October 13, 2021

RE: Isaac Frye Holdings, LLC

I am writing to expand upon a point brought up by Ms. Klinghoffer concerning the grade of the driveway. The Town of Wilton allows driveways with a grade of 10% and they allow a driveway with a grade of up to 12% if certain conditions are met. The plan prepared by Rokeh Consulting, LLC with a date of September 6, 2021 showing the grade of the driveway distorts matters visually. The vertical (Y) axis shows elevations on increments of 5 feet for each line starting at datum level 610. The horizontal (X) axis is on a scale of 50 feet for each line. I have taken the liberty of copying that portion of the Rokeh Plan and showing how a 10% grade significantly alters the amount of material that is required to be removed for the purposes of the driveway. As a consequence, the amount of material required to be removed to site the house is changed drastically too. At a 10% grade, starting at station 0+00 with an elevation of 625 feet, the 10% grade results in an elevation at station 4+42, being the apron outside the driveway of approximately 665 feet, or only

SCALE: 1" = 60'
DATE: SEPT 6, 2021
DR. BY: JR
JOB NO.
SHEET
1 of 1

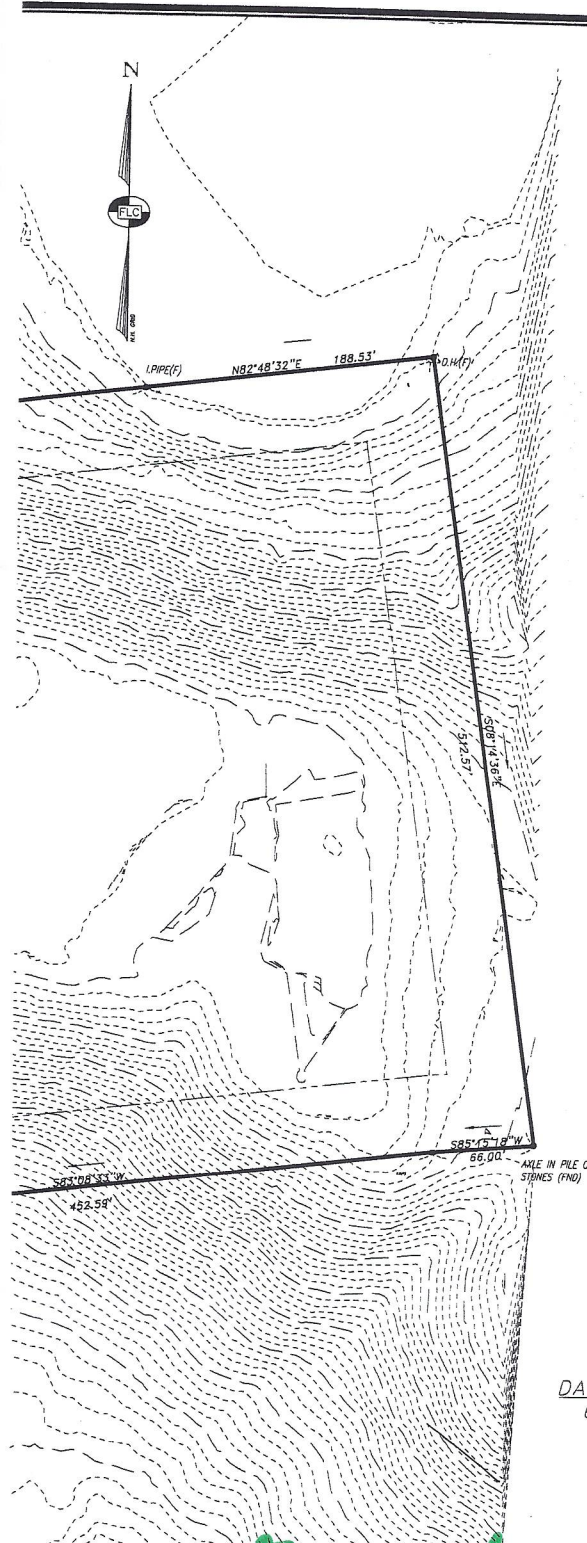
approximately 12 feet elevation change from original ground. The material necessary to achieve the 10% grade can be added to the driveway between stations 0+00 and 3+00 to achieve the 10% grade.

This exercise endorses my assertion to the Zoning Board of Adjustment that the applicant has used no creativity and employed no established engineering principles, but rather this proposal is geared to removal of earth materials from the site.

A review of the design requirements indicates that the applicant's variance application is deficient in that insufficient area is being allowed for other requirements imposed for driveways. Again, compliance with those other requirements would be much easier were the grade of the driveway to be 10% and in some areas increased to 12%.
